WELL INFORMATION:
DJR OPERATING, LLC
30-043-21293 VENADO CANYON UNIT #207H

SUNDRY NOTICES AND REPORTS ON WELLS
Do not use this form for proposals to drill or to re-enter an abandoned well. Use Form 3160-3 (APD) for such proposals.

DJR Operating LLC. has an approved APD for the proposed well, Venado Canyon Unit 207H (API 30-043-21293) which is part of the VENADO CANYON UNIT. DJR Operating is submitting this sundry to change the Drilling Plan.

DRILLING PLAN **Vendado Canyon Unit 207H** **Sandoval County, New Mexico**

WELL LOCATION AND ACREAGE DEDICATION PLAT

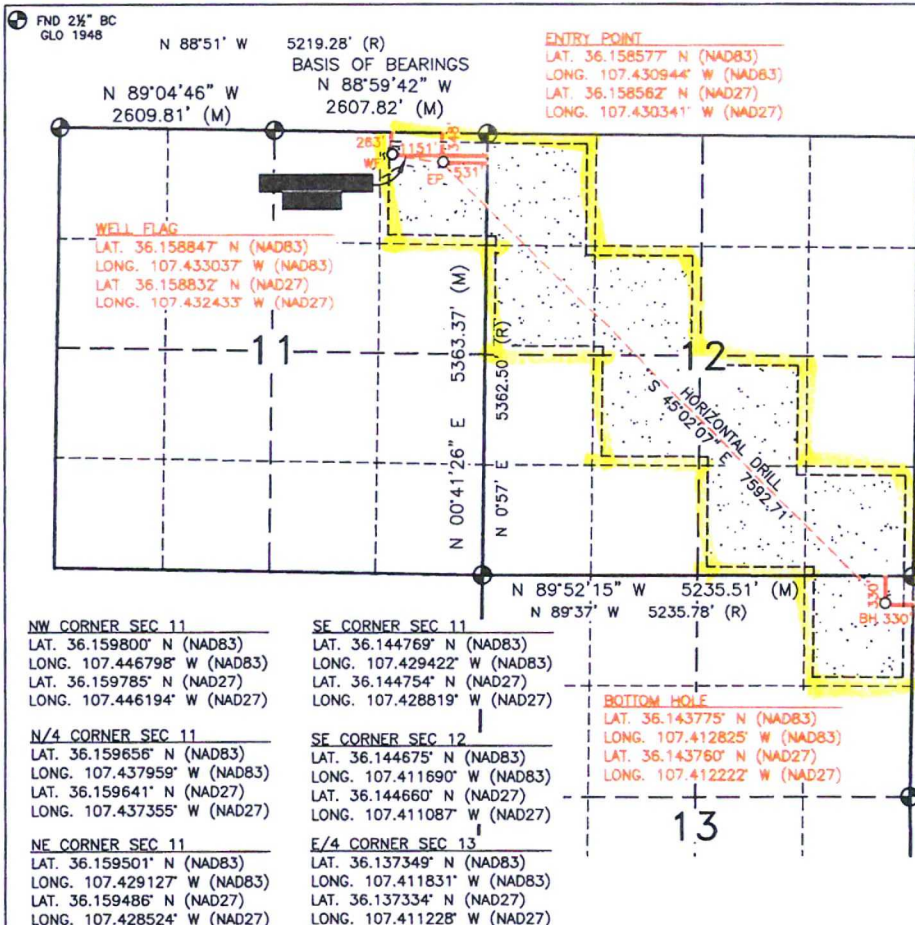
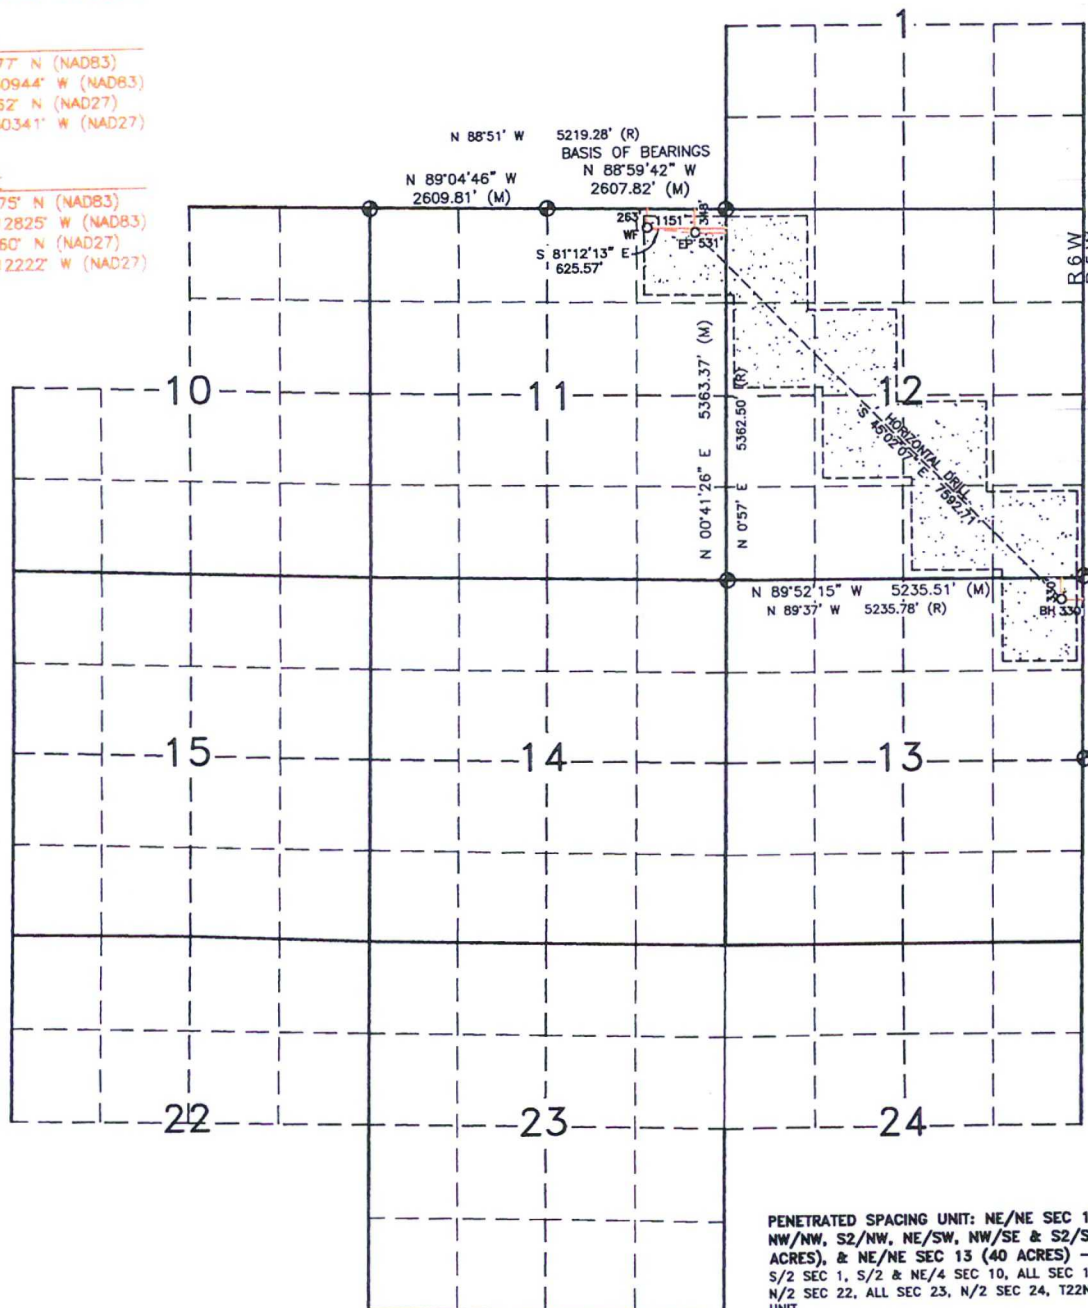
Please find attached an updated C-102 package reflecting the BHL and the new drilling plan.
